CHART STANDARDIZATION & PAPER CHART WORKING GROUP (CSPCWG)

CSPCWG Letter: 03/2012

Subject: Draft revision of S-4 Section B-300 to B-330 – Round 2

CONSOLIDATED RESPONSES TO CSPCWG LETTER 03/2011**S-4 SECTION B-300 TO B-330 – ROUND 1**

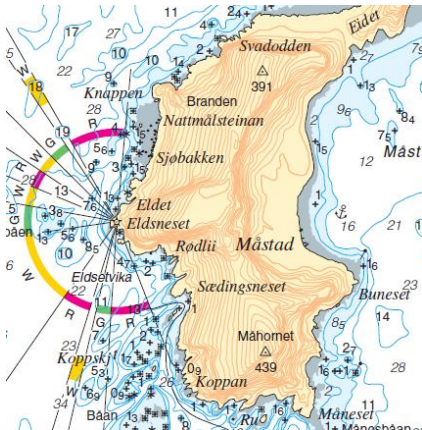
NO Comment: This is a very long and complicated sentence that should be rewritten.

Chairman: accepted; rewording attempted.

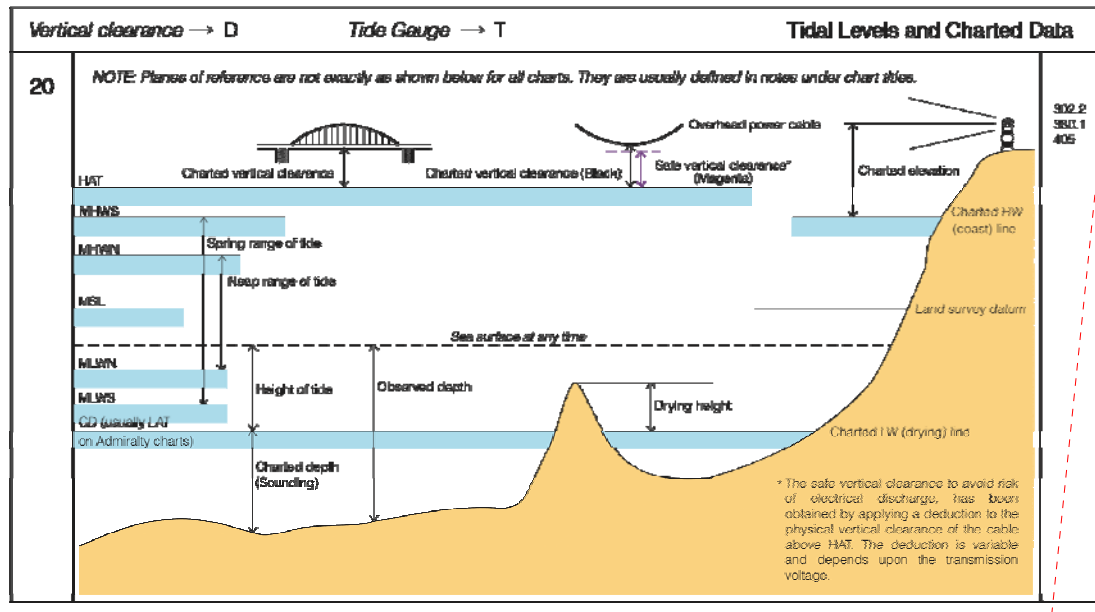
Comment: DID: some small changes required to this graphic. A marked up copy will be supplied.
